TECHNICAL BULLETIN

Climate Control System – Revised Pipe and Pressure Switch Location

82-45

MODEL Sedan (4.0) Range 1993-94 MY DATE 8/95
with R-134a systems

ILLUSTRATION 1

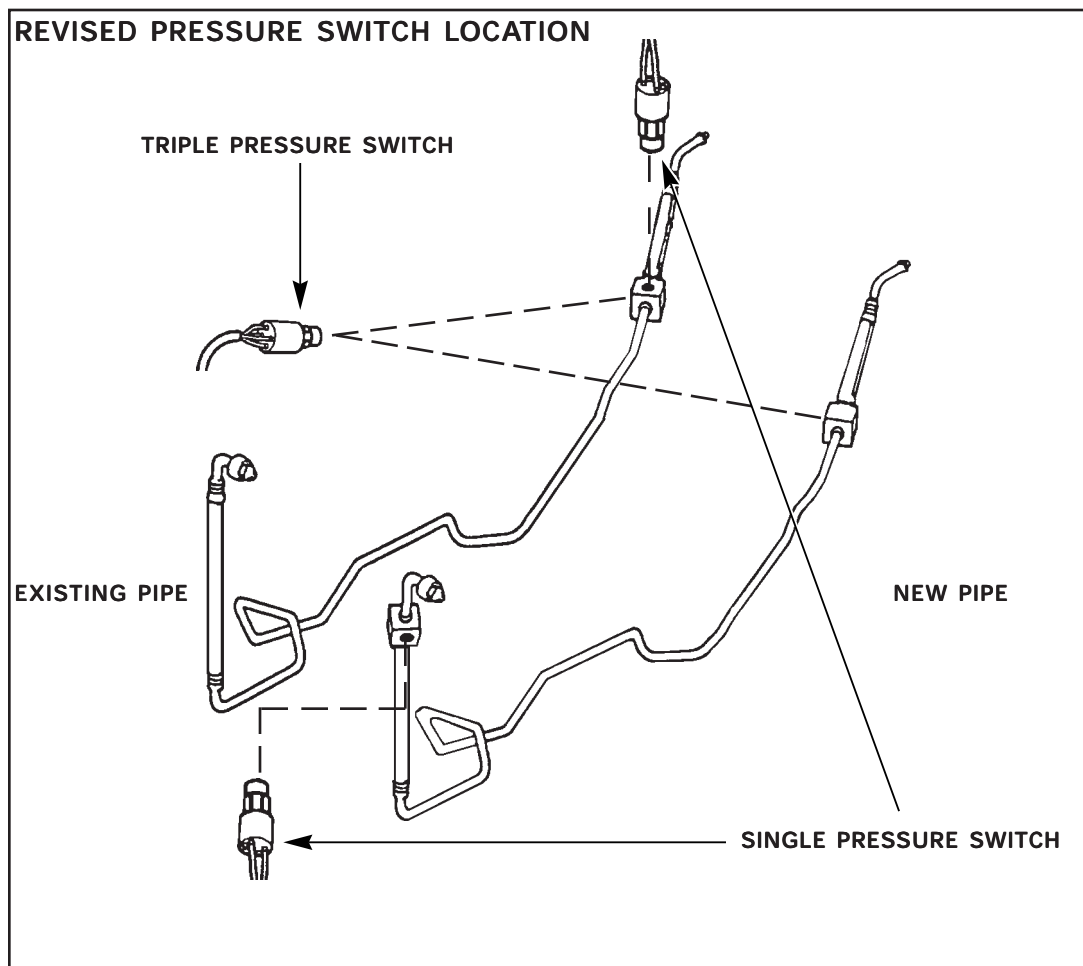
The high-pressure pipe from the condenser to the expansion valve has been superseded to part no. MMD-7360AB plus LMD 3997CA. This pipe separates the single pressure switch from the triple pressure switch to a location at the opposite end of the assembly. The triple pressure switch remains near the expansion valve, while the single pressure switch is relocated to the condenser end of the pipe, Illustration 1.

When installing the later style pipe (MMD-7360AB), obtain the link lead LMD-3997CA to connect the single pressure switch to the vehicle harness.
